Subject: Draft Work Plan for Mitigation of Indoor Air and Well Water, Maryland Square Shopping Center

Facility: Al Phillips the Cleaner (former)
3661 S. Maryland Parkway
Las Vegas, NV

Facility ID: H-000086

ATTACHMENT 1 – SPECIFIC COMMENTS

Figure 1. The APNs shown in the following sketch cover the area east of Spencer St and east of Eastern Ave.

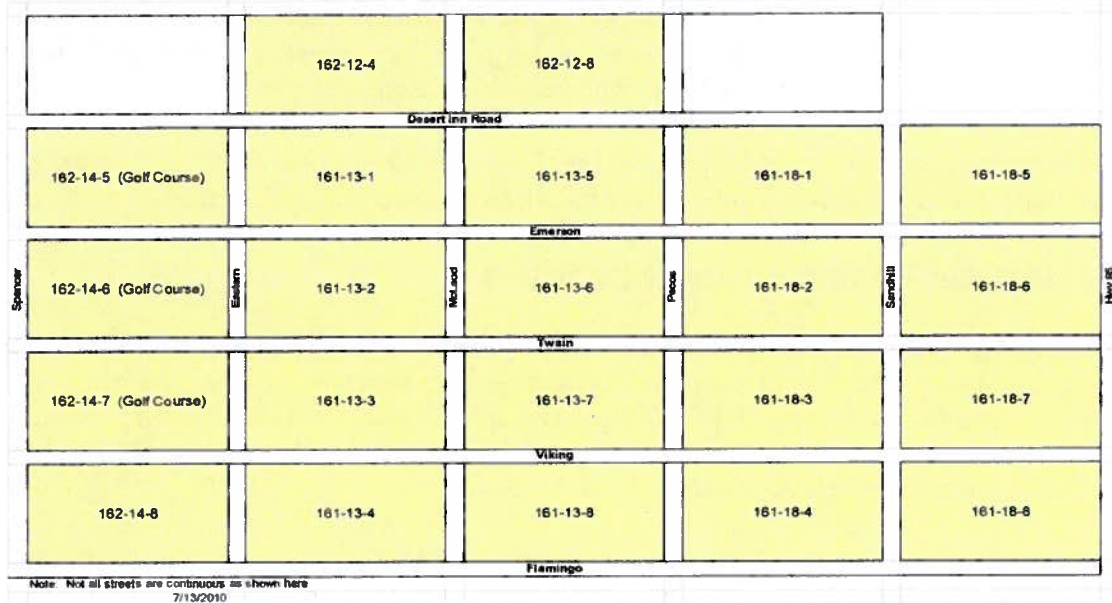
A search of the DWR database, with detailed cross-checking, is anticipated to result in only a handful of domestic wells in the area. Field checks of these wells may be required.
